UNITED STATES
NUCLEAR REGULATORY COMMISSION
WASHINGTON, D.C. 20555-0001

SUBJECT: DIABLO CANYON POWER PLANT UNIT NOS. 1 AND 2 – FLOOD HAZARD
MITIGATION STRATEGIES ASSESSMENT (CAC NOS. MF7919 AND MF7920;
EPID L-2016-JLD-0007)

STAFF ASSESSMENT RELATED TO THE
MITIGATION STRATEGIES FOR
DIABLO CANYON POWER PLANT UNIT NOS. 1 AND 2
AS A RESULT OF THE REEVALUATED FLOODING HAZARDS REPORT
NEAR-TERM TASK FORCE RECOMMENDATION 2.1- FLOODING
CAC NOS. MF7919 AND MF7920

Figure 3.2-3. Figure showing locations within the Diablo Canyon powerblock where manual adjustments were made to the refined FLO-2D computer code used to model LIP at the reactor site. Source: PG&E (2017a)

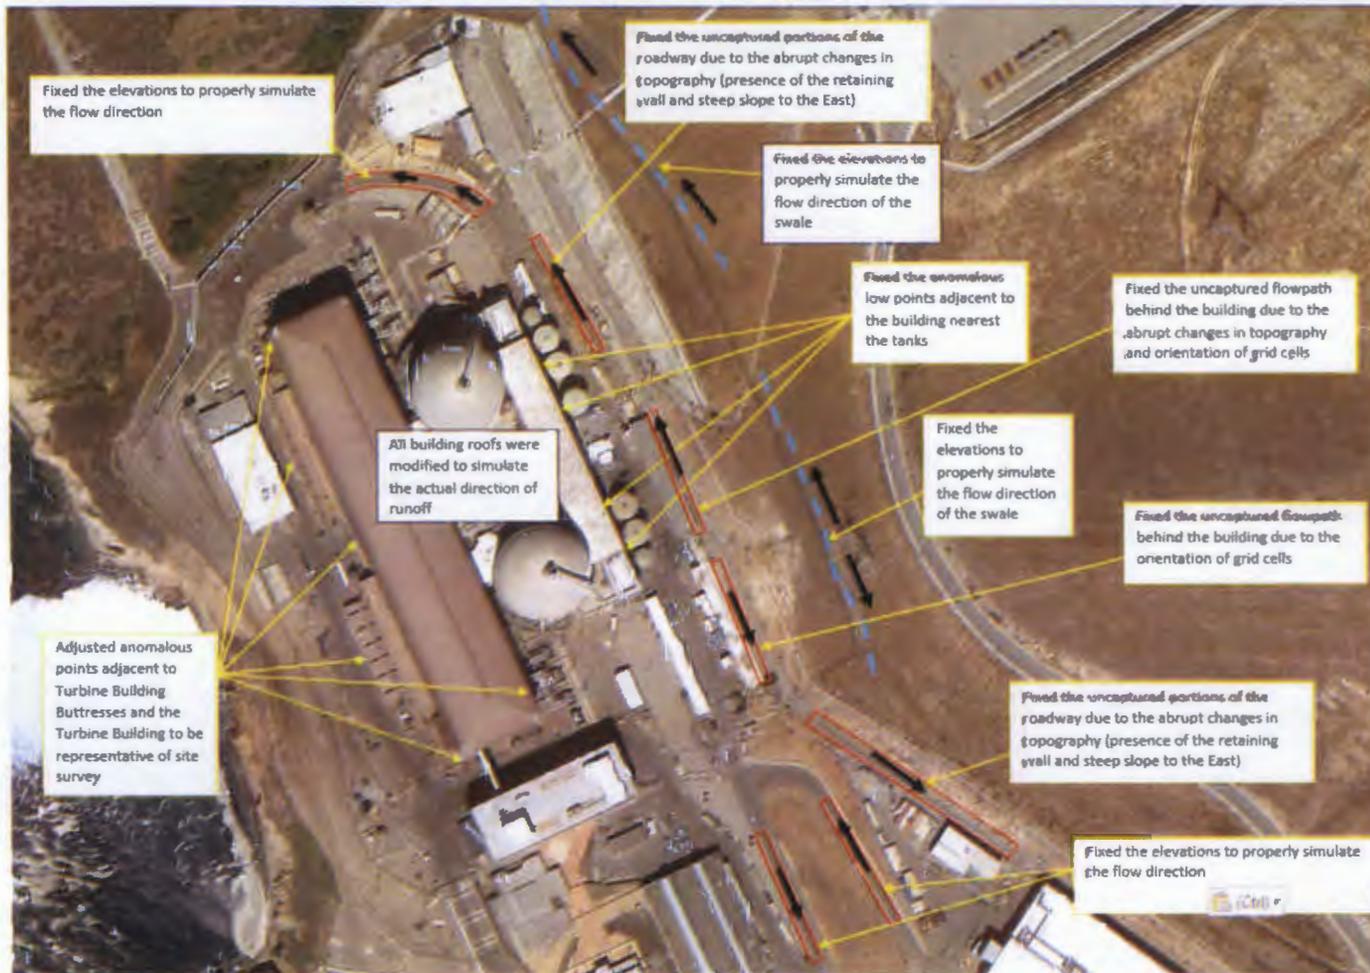
- Manual adjustments of missing FLO-2D flow paths within the modeling domain consistent with the topography and other as-built features within the powerblock (includes corrections for missing flow areas and continuation of curbed features). See Figure 3.2-3.

Based on the analytical approach described above, the approximate location on the roadway where the licensee expected the overflow to occur is shown in Figure 3.2-4. An elevation for this location was obtained from a topographic survey of the site. The location where overtopping could be expected along Reservoir Road is essentially at the end of the powerblock footprint and at an elevation below that of important reactor structures and systems. At this location, the expected flow direction for runoff is predicted by the licensee to be southwest toward the Pacific Ocean, and away from the powerblock (yellow arrow on Figure 3.2-4). The licensee thus concluded that runoff from the parcel of land to the east of Reservoir Road would not contribute additional floodwater flux (runoff) into the powerblock.

Figure 3.2-6a. Door and other opening locations shown in relation to safety and non-safety-related structures at the Diablo Canyon nuclear power plant site at the 140-ft. sundeck elevation. Source: PG&E (2017a)

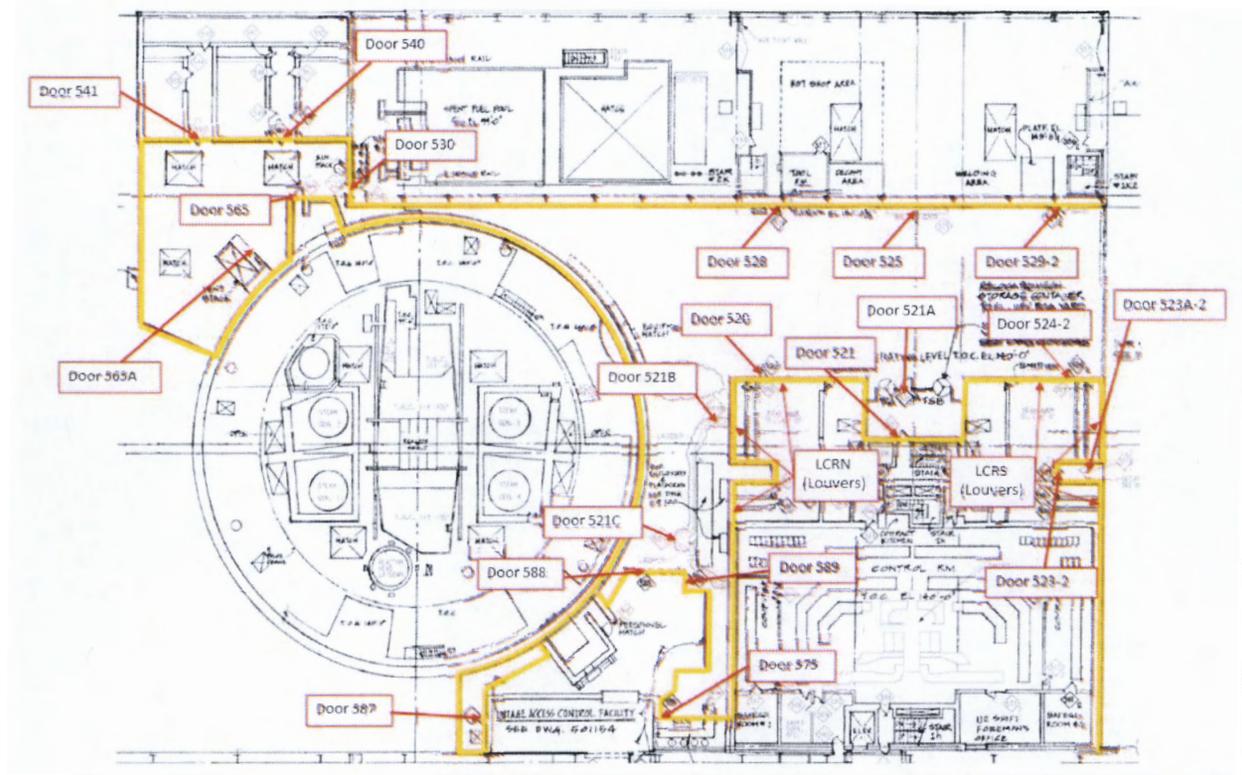
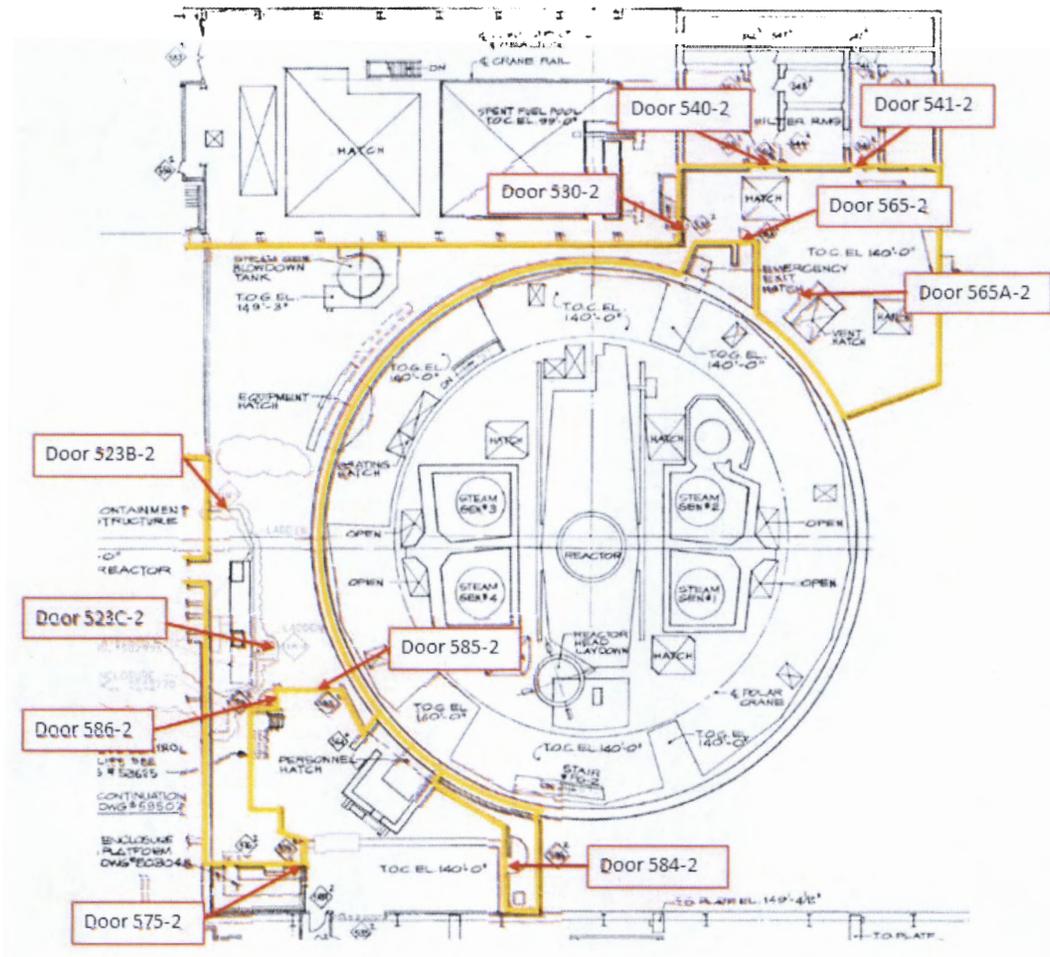
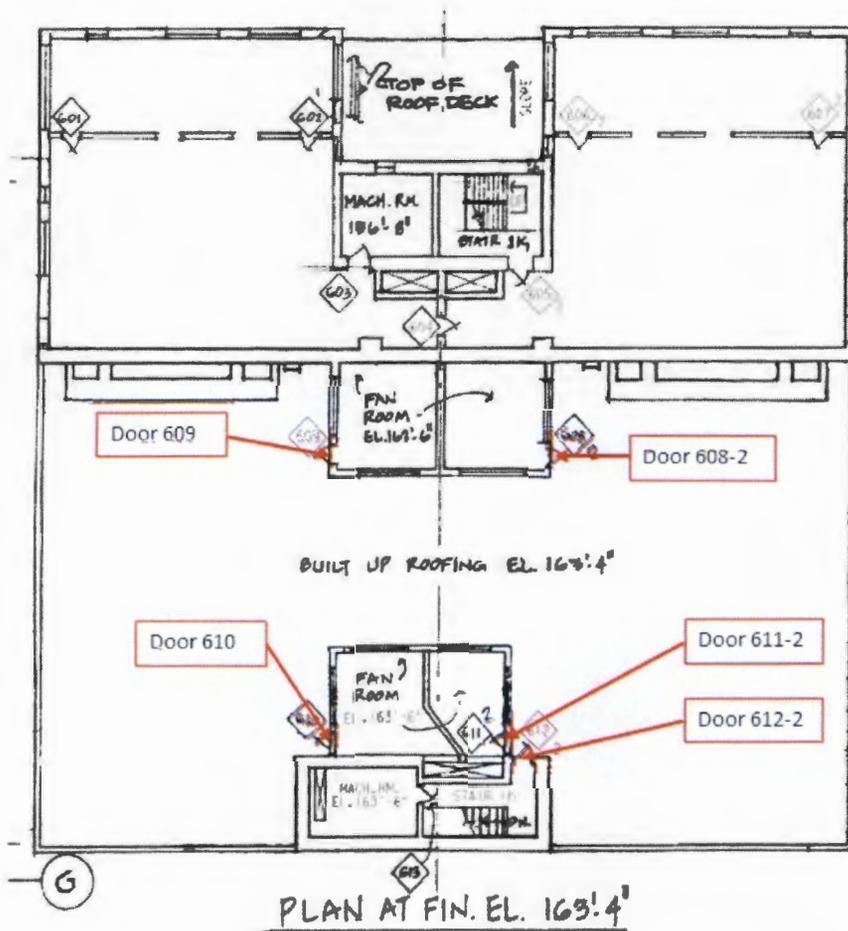
The licensee identified multiple potential locations around each of the two reactor units and other structures by which flood water could potentially pond near the structures in question. In Table 1 of the MSA (PG&E, 2017b), the licensee identified POIs for which LIP-related flood waters exceed the threshold elevation of some of the door openings. Those POIs include both safety-related and non-safety-related buildings and structures. Key monitoring locations around the two reactor units and turbine building identified by the licensee are shown in Figures 3.2-5a and 3.2-5b. In its refined LIP analysis, the licensee identified a total of 61 POIs potentially susceptible to water ingress; 21 more than reported in the revised FHRR (PG&E, 2016a). Those additional POIs occur along what the licensee referred to as the "[elevation] 140-ft sundeck." See Figures 3.2-6a-c.
